City of Pensacola

Planning Board

Agenda

2. 23-927 700 BAYFRONT PARKWAY – GATEWAY REDEVELOPMENT DISTRICT – AESTHETIC REVIEW APPLICATION
*Attachments: Images
Application and Materials_10.17.2023
Review Comments_700 Bayfront Parkway
Sec._12_3_12(1)_Gateway Redevelopment District*
3. 23-928 801 E. GREGORY STREET – GATEWAY REDEVELOPMENT DISTRICT – AESTHETIC FINAL REVIEW APPLICATION
*Attachments: Images
September Items
801 E. Gregory Street_Application and Materials
Review Comments_801 E. Gregory Street
Sec._12_3_12(1)_Gateway Redevelopment District*

**EXISTING
EXTERIOR
ELEVATIONS**

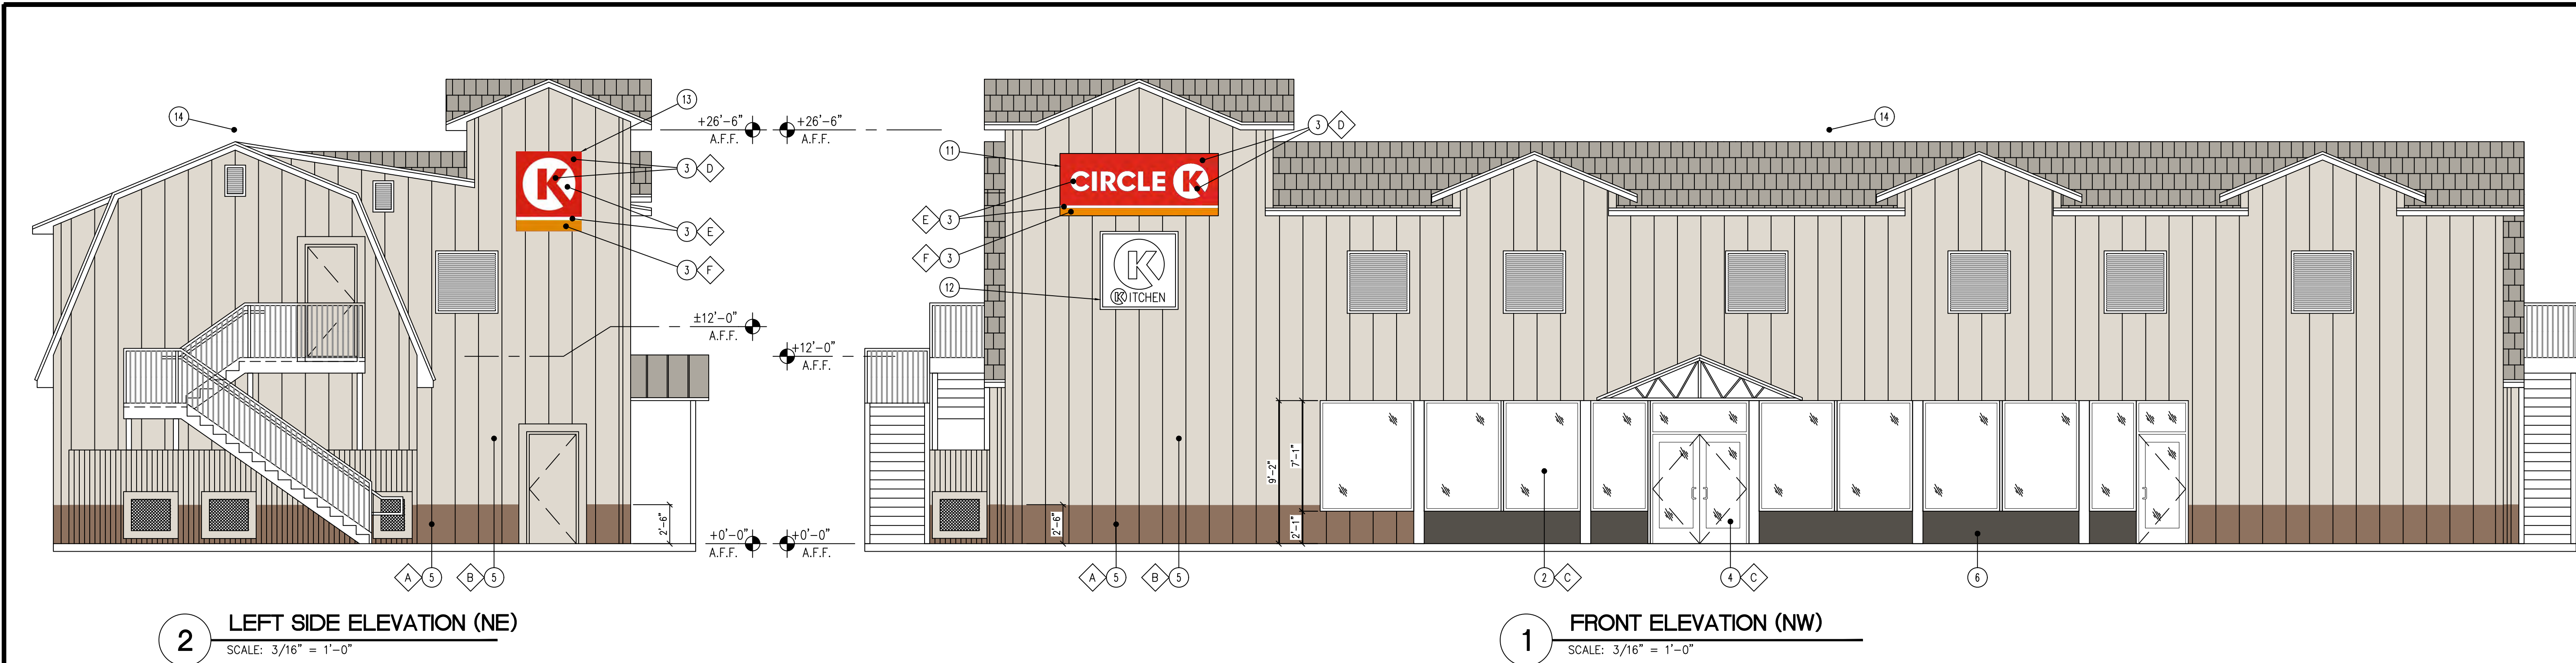
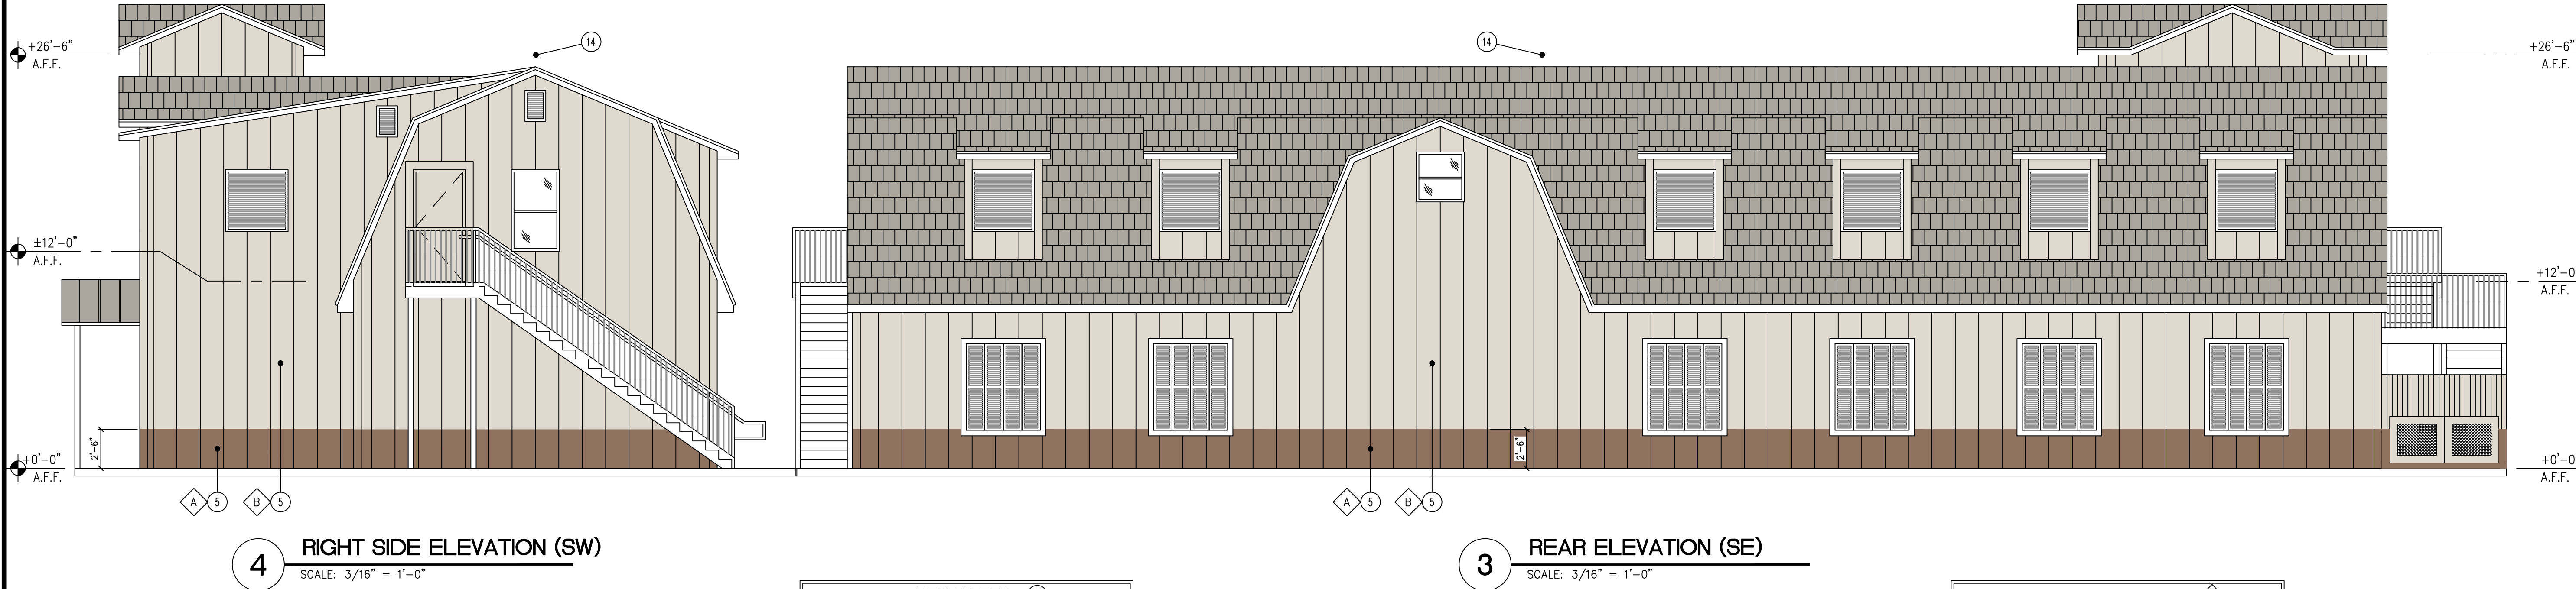
Replace siding and windows
Put awning over entrance and take out other 2 at front.
If awning approved, saw cut dock and re-pour, if not patch
Replace Down Home Kitchen sign with K Kitchen sign

- Replace stairwell awning
- Paint stairwell
- Dumpster and AC enclosures with wood fencing.
- Bell tower has opening to store - close

60 23080 Canopy.dwg

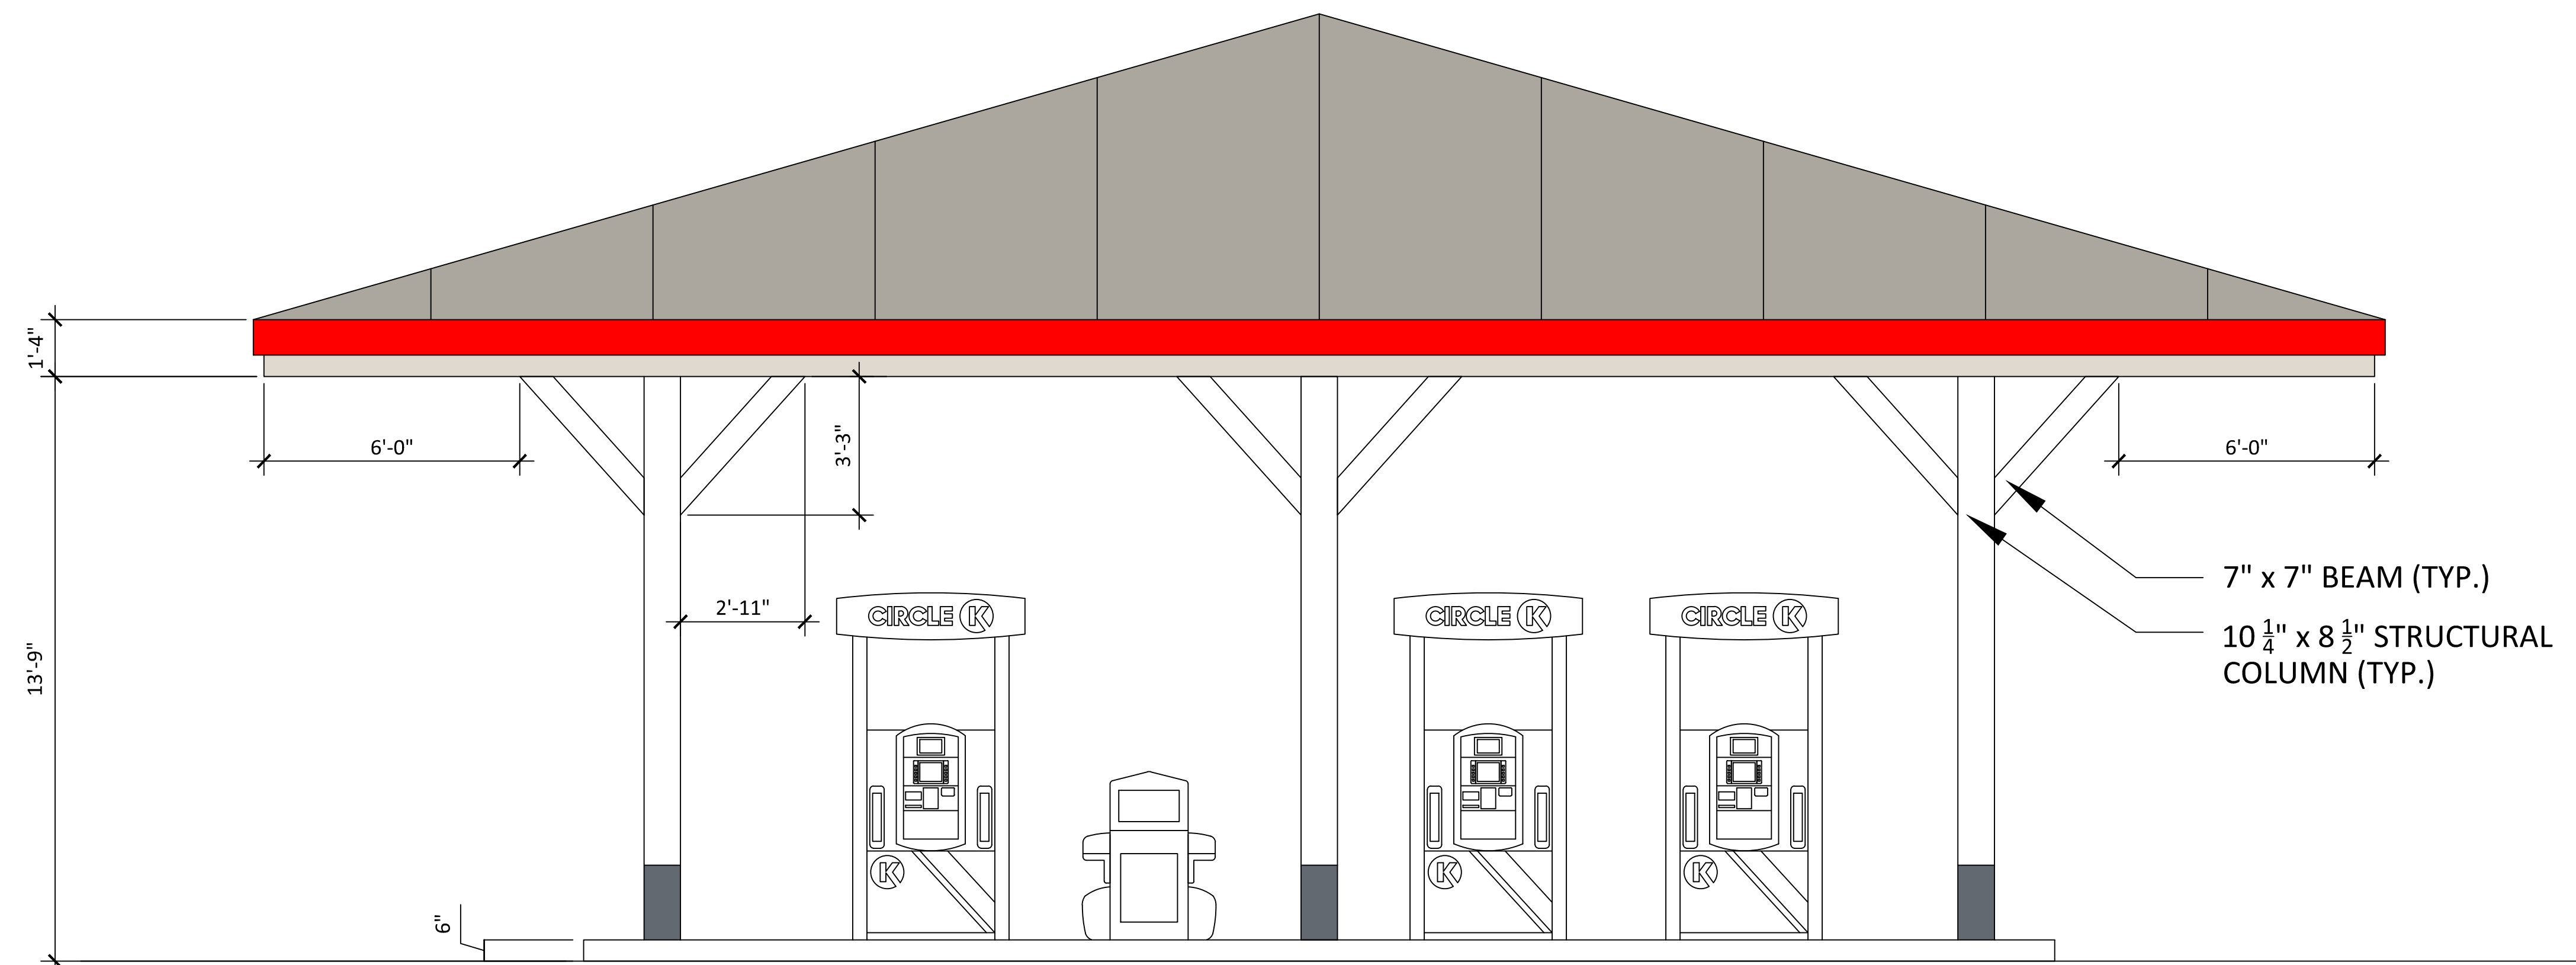
Canopy - rust/dents, replace ACM panel
Stain concrete - lot and top and sides of dog bones – grey
Lot – repair cracks/holes
